# ADDENDUM

Project:	Garvin Park Activity Zone 45 Don Mattingly Way Evansville, Indiana	Addendum No.:	002
		Date:	June 2, 2025
Owner:	Evansville Parks and Recreation 100 East Walnut Street Evansville, Indiana 47713	Project Number:	2402-146
		Contract for:	All Disciplines

Civil Utility Plan 45 Don Mattingly Way Evansville, IN 47711

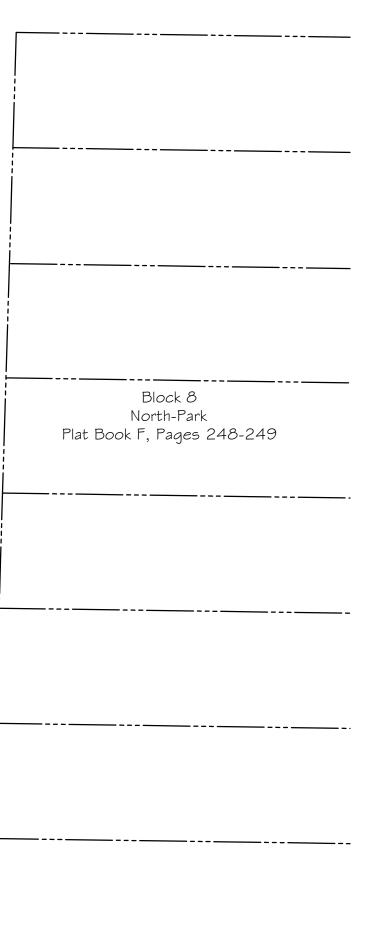
- 2-6 Contractor shall video inspect the existing sewer pipe under Herndon Avenue to which the new sanitary sewer will be connected as part of the Base Bid work and report the results of the inspection to the Architect for further direction, prior to constructing the new sewer line in this area. Refer to the attached C103 Revision 01.
